**CORRECTIONS TO 2008 REEDS PBO SMALL CRAFT ALMANAC**

CROSS locations and areas of responsibility

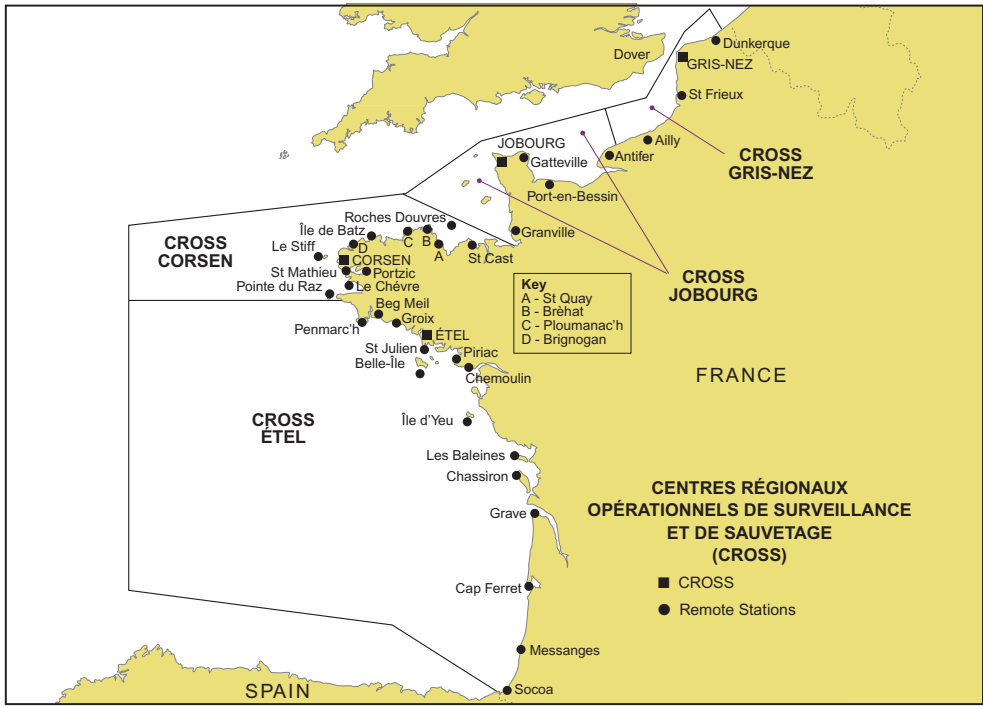
**137, CROSS locations and areas of responsibility**, substitute amended diagram on page 10 showing revised remote stations.
